July 21, 2010

**Re: Construction Storm Water Inspection at Hart Road Stockpile Site.
Permit Number: 4GC03224*AG**

Figure 1: Sediment Pond lacks a proper Outlet Structure

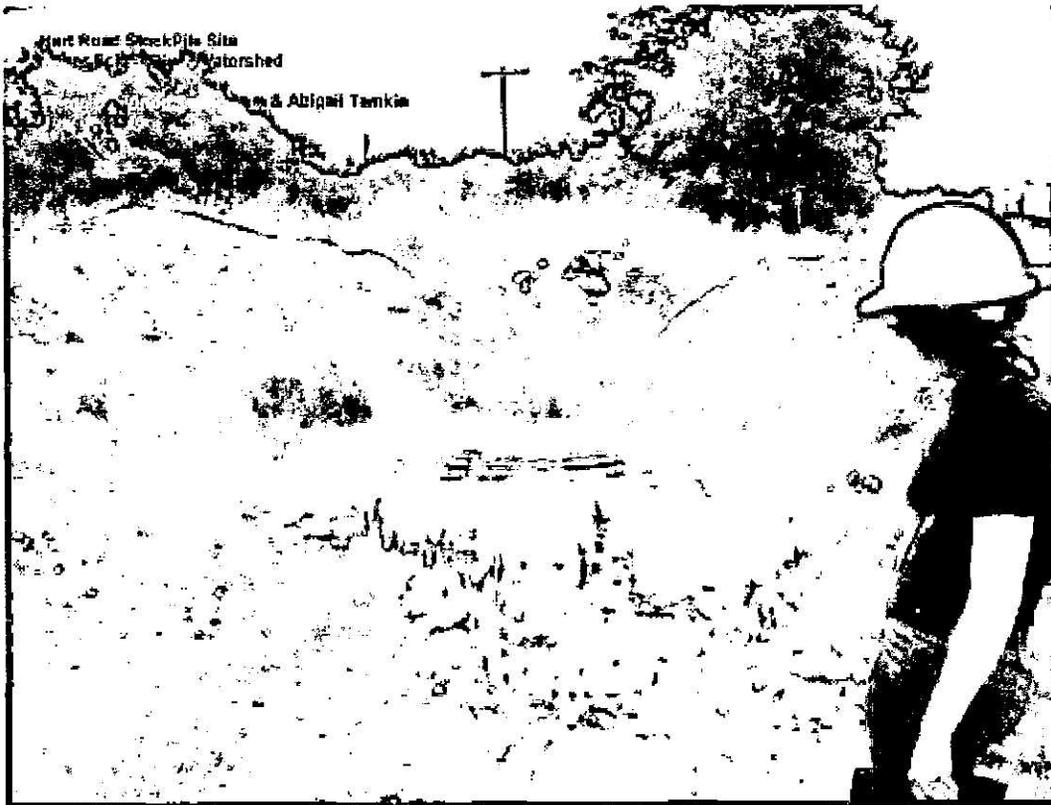
- Silt fence along the southern end of the project requires maintenance at this time.
- Stock piles noted on the site must be seeded and mulched to address sediment and erosion controls.
- It was noted, the sediment pond does not incorporate a sediment control structure such as a temporary riser. All sediment ponds must be modified to address sediment control. Corrective measures are expected within three days from receipt of this letter (Figure 1).
